COUNTY OF SAN MATEO

Date: March 14, 2001

March 27, 2001

SUBJECT: Alameda de las Pulgas Interim Striping - Ashton to Avy Avenues - West Menlo Park Area

ELIMINATE BULB-OUT AT AVY AVENUE AND DELINEATE TWO LANES AND A SHOULDER LANE ON THE ALAMEDA SOUTH OF AVY AVENUE

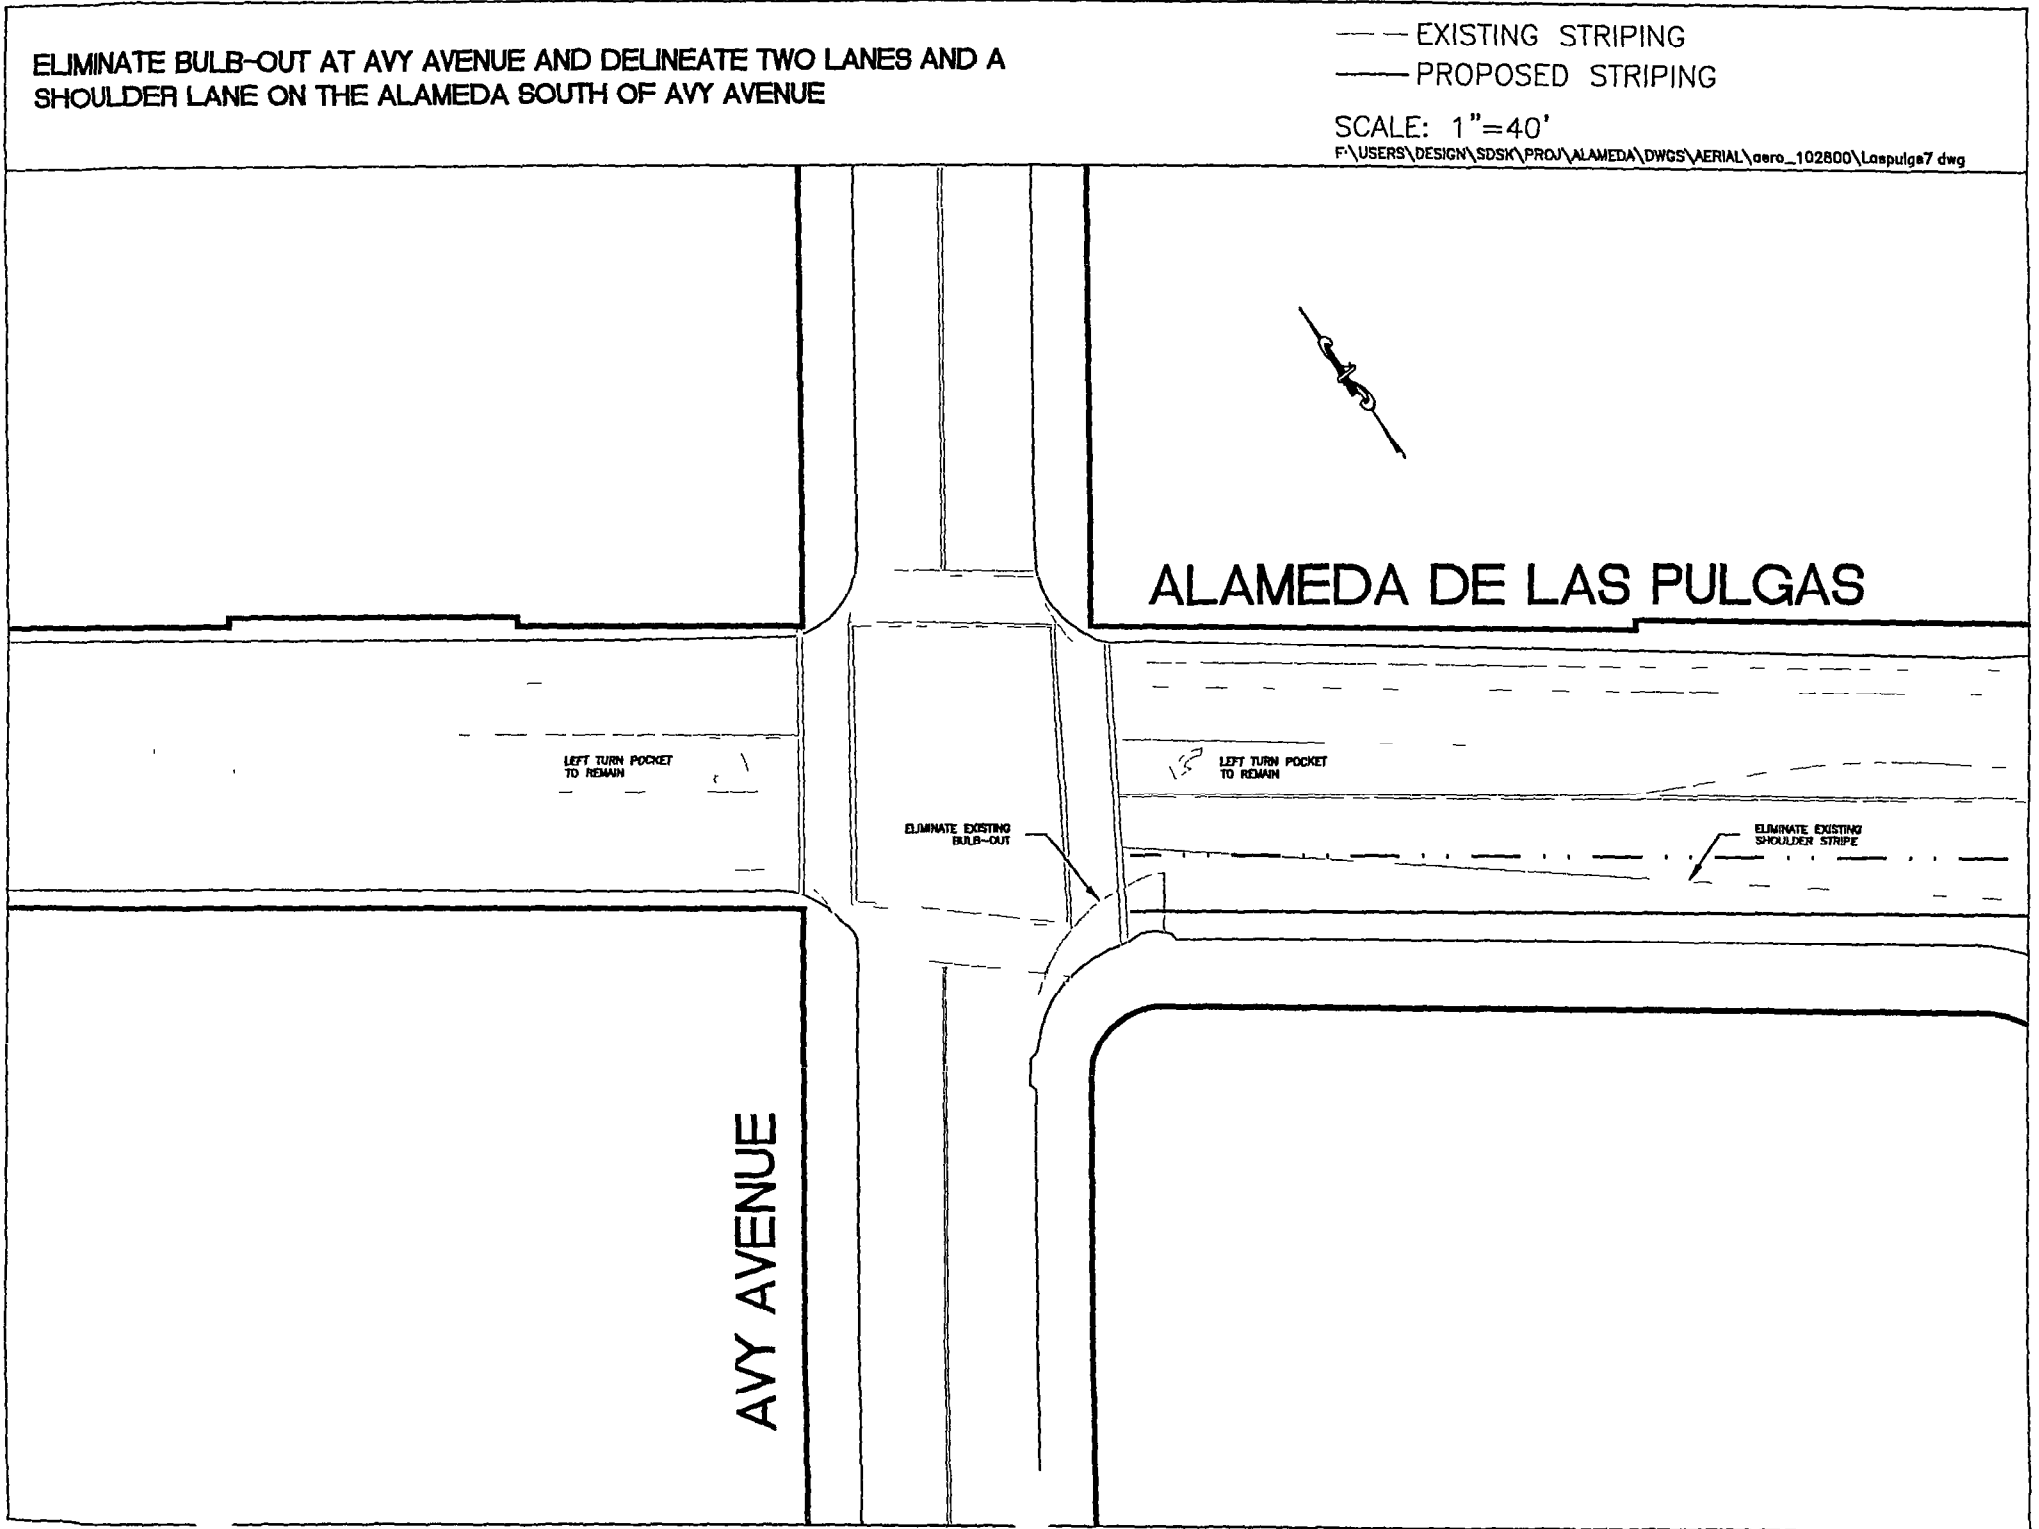
LEFT TURN POCKET TO REMAIN

ELIMINATE EXISTING BULB-OUT

LEFT TURN POCKET TO REMAIN

ELIMINATE EXISTING SHOULDER STRIPE

4. Reduce the "bulb-out" at the southwest corner of the Alameda/Avy Avenue intersection. We received several comments from motorists stating that delays on eastbound Avy Avenue traffic can be significantly reduced if this "bulb-out" was removed to facilitate right turn movements. The consultant does not believe that this will improve the right turn movement. However, there may be a secondary benefit of facilitating southbound traffic through this intersection thus reducing the backup. Proponents of the Streetscape Plan believe that the "bulb out" is necessary to reduce the width of the intersection to aid pedestrians in crossing the Alameda. However, this is a signalized intersection and the signals are pedestrian activated.

DELINEATE LEFT TURN LANE AND SHARED RIGHT/THROUGH LANE ON AVY AVENUE
EASTBOUND APPROACH

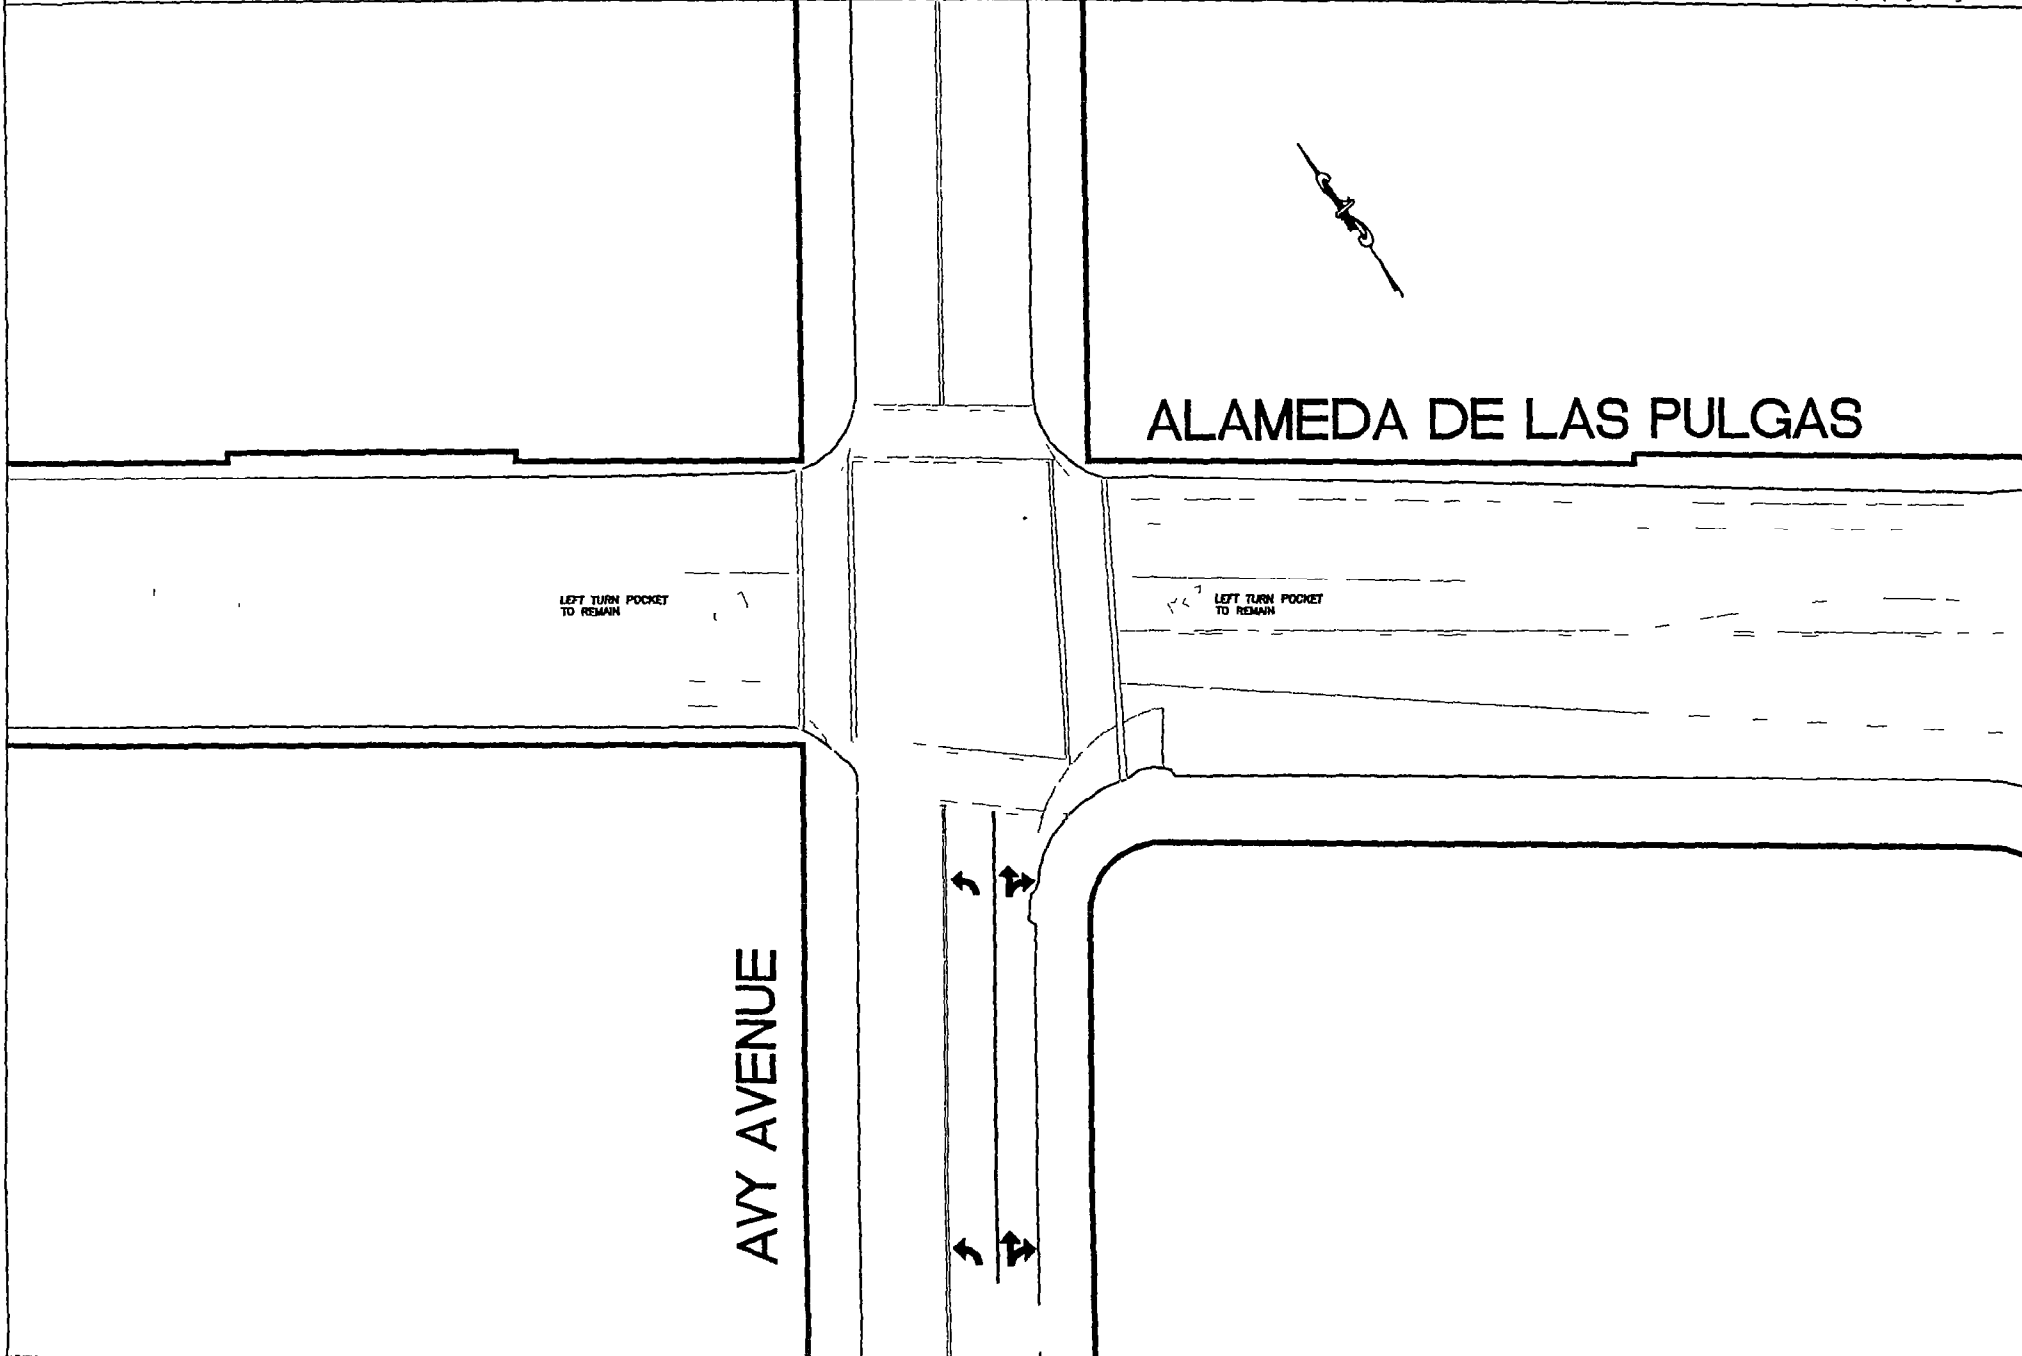
LEFT TURN POCKET
TO REMAIN

LEFT TURN POCKET
TO REMAIN

1. Stripe the eastbound approach on Avy Avenue with a dedicated left-turn lane and a shared right-turn/through lane. The Consultant believes that this modification will improve this leg of the intersection from LOS 'F' (extreme delays) to LOS 'C' (average delays) in the a.m., while maintaining a LOS of 'B' for p.m. traffic.
2. Increase the minimum green times for northbound and southbound Alameda signals and increase the "delay time" on Avy (i.e. the time between when a vehicle is "sensed" on the side street and when the signal changes).
